Shunt screws replacement

Working instructions, Version 2.0

Figure 1: Torn off head of brass screw on shunt

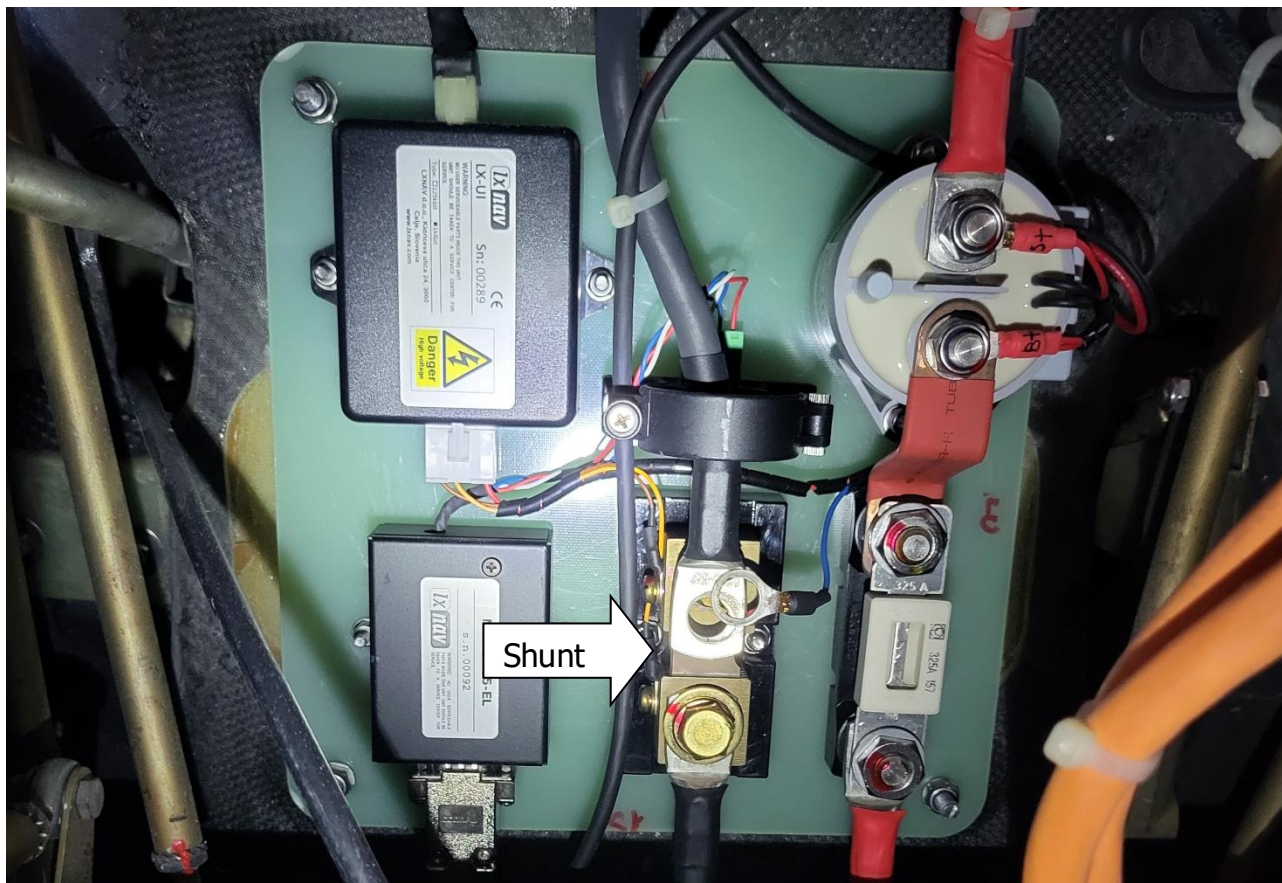
Recently there were a few occurrences of torn off heads, from one of the two brass screws, which holds minus power cables attached to the shunt. One power cable goes to the negative pole of FES battery packs, and one goes to the motor controller.

Such screw failure, if not detected and corrected, could lead to failure of FES system.

Two brass screws used to fasten the high-current cables to the shunt must be replaced with steel screws as described below.

Figure 2: Proper orientation of Schnorr safety washer

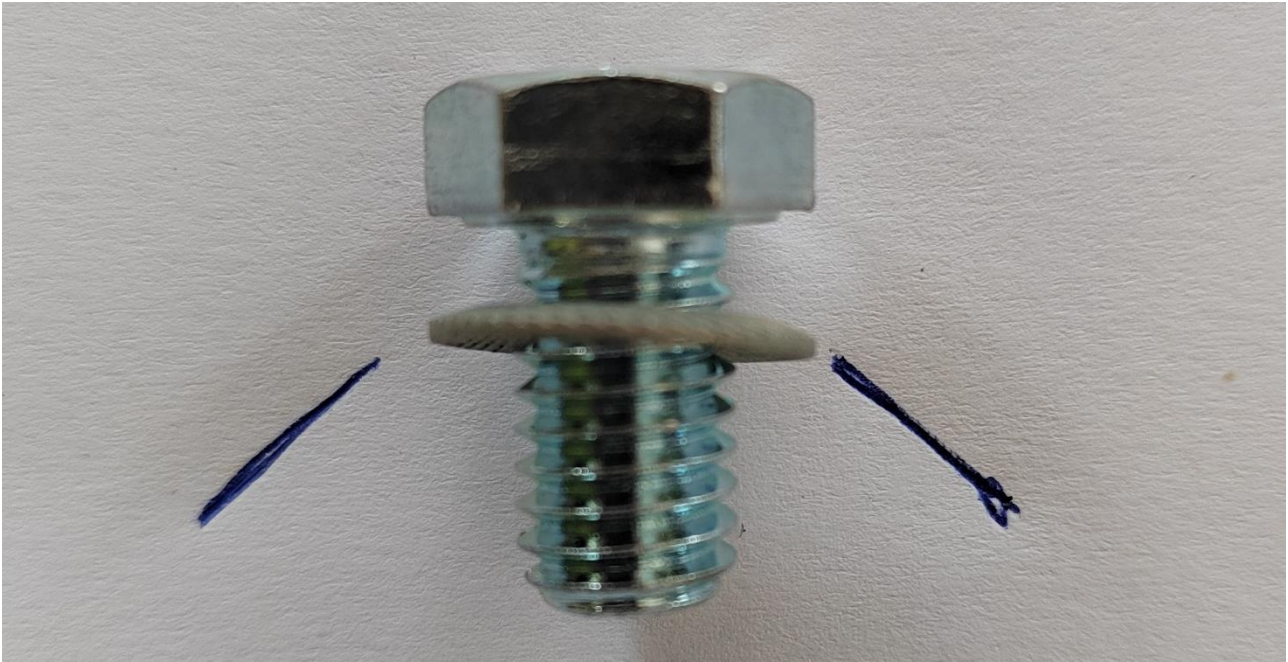
During installation of new steel screws and "Schnorr" safety washers, ensure the correct orientation of the safety washer, see Fig. 1.

The steel screws must be additionally secured in the threaded area with medium strength thread-locker adhesive (Loctite 243 or similar).

Torque wrench should be set to 17 Nm of tightening moment.
